MIL-C-22442/26D(AS)
AMENDMENT 1
17 October 1994

CABLE ASSEMBLIES, RADIO FREQUENCY (AIRCRAFT AUDIO)
CX-13126A/A

This amendment forms a part of MIL-C-22442/26D(AS), dated 18 February 1992, and is approved for use by the Naval Air Systems Command, Department of the Navy and is available for use by all Departments and Agencies of the Department of Defense

FIGURE 2 Cable assembly headset extension P/N M22442/26-2 (see requirement 1)

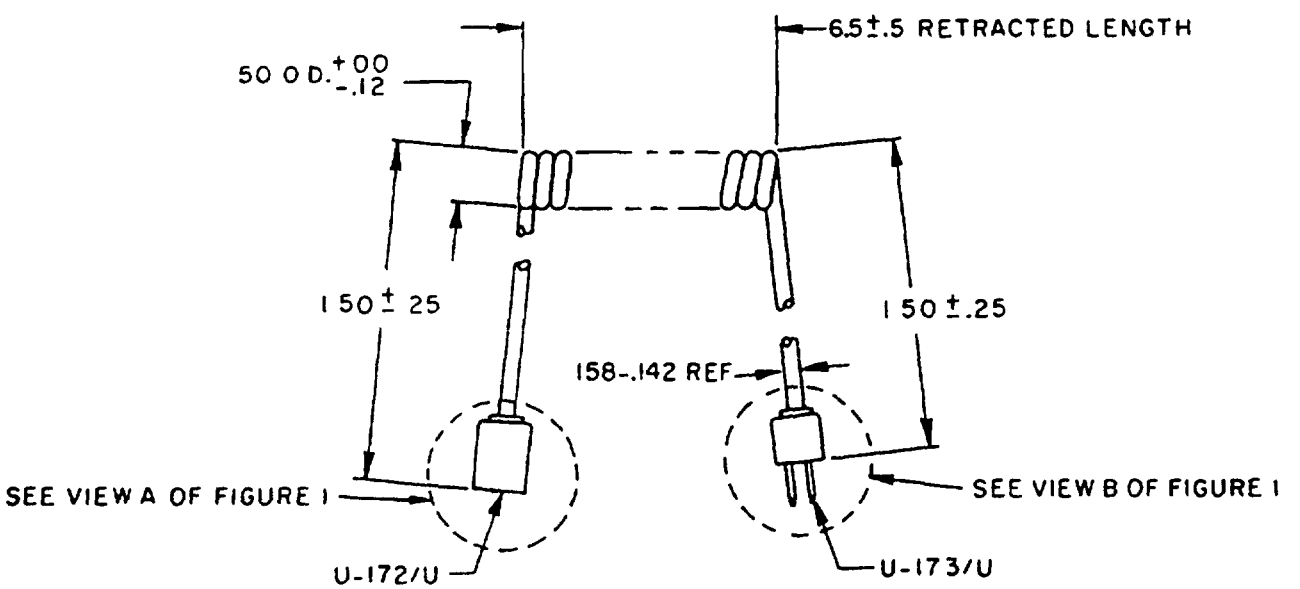
FIGURE 2 Delete existing figure 2 and substitute with new figure 2 below
